TSG-RAN Meeting #8 *RP-000210*
Düsseldorf, Germany, 21 – 23 June 2000

Title: **Agreed CRs to TS 25.133**

Source: **TSG-RAN WG4**

Figure 5-1: Illustration of parameters for soft handover measurement reporting test case

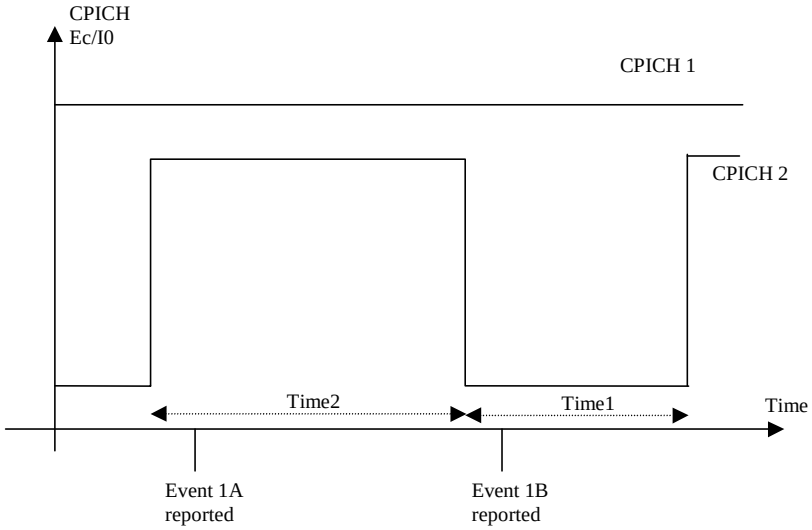
This test will derive that the terminal makes correct reporting of an event and that the measurement accuracy of the CPICH_Ec/Io and ~~CFN-SFN~~ SFN-CFN observed timed difference between Cell 1 and Cell 2 is within defined limits in AWGN propagation condition..

The DL reference measurement channel 12.2 kbps as specified in Annex A, ~~Sub~~sub-clause A.3.1 of TS25.101 shall be used ~~but~~ with power control turned on ~~[see 25.101].Correct reporting of neighbours and CPICH_Ec/Io and timing measurement accuracies in AWGN propagation condition.~~

~~This test will derive that the terminal makes correct reporting of an event and that the measurement accuracy of the CFN-SFN observed timed difference between Cell 1 and Cell 2 is within defined limits~~. Cell 1 is current active cell. The CPICH_Ec/Io ~~power~~ level of Cell 1 is kept constant and the CPICH_Ec/Io~~power~~ level of Cell 2 is changed ~~using~~ ~~$(\hat{I}_{or}/I_{oc})$,~~ as illustrated in figure 5-1and table 5.1. Hysteresis, Threshold and Time to Trigger values are given in the table below and they are signalled from test device. In the measurement control information it is indicated to the UE that event-triggered reporting with Event 1A and 1B shall be used, SFN has to be decoded for neighbour cells. CPICH Ec/~~I0~~ Io and the ~~CFN-SFN~~ SFN-CFN observed timed difference has to reported together with Event 1A reporting. New measurement control information, which defines neighbour cells etc., is always sent during time period Time 1. The number of neighbour cells in the measurement control information is 24.

Figure 5.2: Illustration of the test case

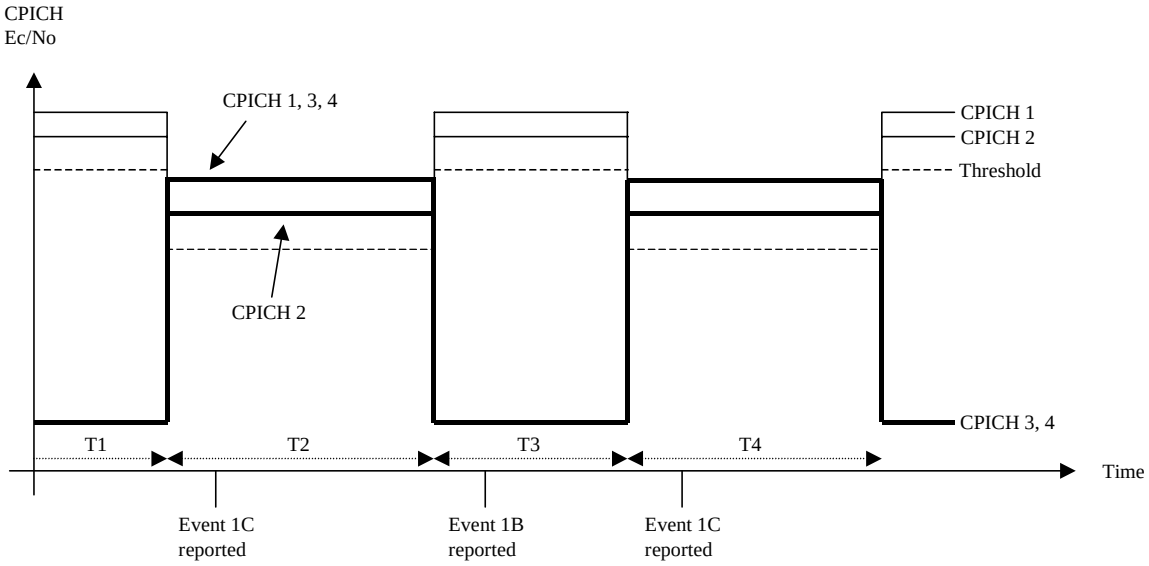
In figure 5-2 an illustration of the test case is shown with the parameters specified in table 5.2 and 5.3 . ~~In the test 4 cells are present. Cell 1 and 2 are within the active set, as illustrated in figure 5-2. The $\hat{I}_{or}/I_{oc}$ level of Cell 1 and 2 is kept at a constant level according to table 5-3 and the power level of cell 3 and 4 is changed over time by changing ($\hat{I}_{or}/I_{oc}$) according to table 5-4~~ Hysteresis, Threshold and Time to Trigger values are given in the tables below and they are signalled from the test device. In the measurement control information it is indicated to the UE that event-triggered reporting with Event 1C and 1B shall be used. CPICH Ec/Io and ~~CFN-SFN~~SFN-CFN -observed time difference shall be reported together with Event 1C. New measurement control information, which defines neighbour cells etc., is continuously sent. The number of neighbour cells in the measurement control information is 32.

Figure 5-3: Illustration of parameters for handover measurement reporting test case

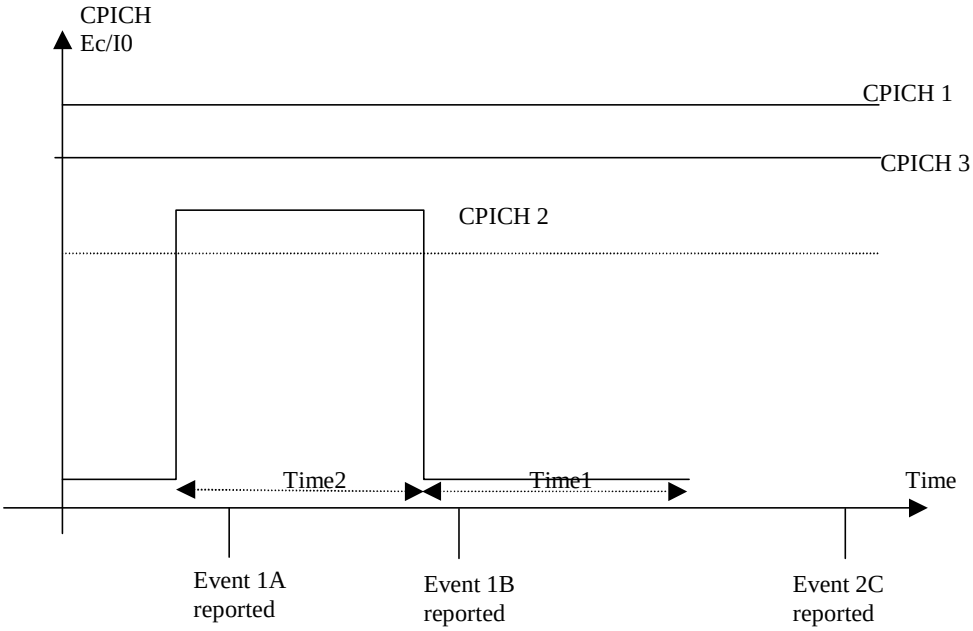
~~5.1.2.2.1.2.2~~5.1.2.2 ~~CPICH_Ec/Io measurement accuracy and correct~~Correct reporting of neighbours in AWGN propagation condition.

The CPICH_Ec/Io~~power~~ level of Cell 1 and Cell 3 are kept constant and the power level of Cell 2 is changed using ($\hat{I}_{or}/I_{oc}$),as illustrated in Figure5-~~2~~3. Hysteresis, Absolute threshold and Time to Trigger values are given in the table below and they are signalled from the test device. In the measurement control information it is indicated to the UE that event-triggered reporting with Event 1A, 1B and 2C shall be used. The CPICH Ec/I0 of the best cell on the un-used frequency has to reported together with Event 2C reporting. New measurement control information, which defines neighbour cells etc., is always sent before compressed mode pattern starts. The number of neighbour cells in the measurement control information is 24. The X number of neighbours are on the un-used frequency. The BLER of the current active link is also measured.
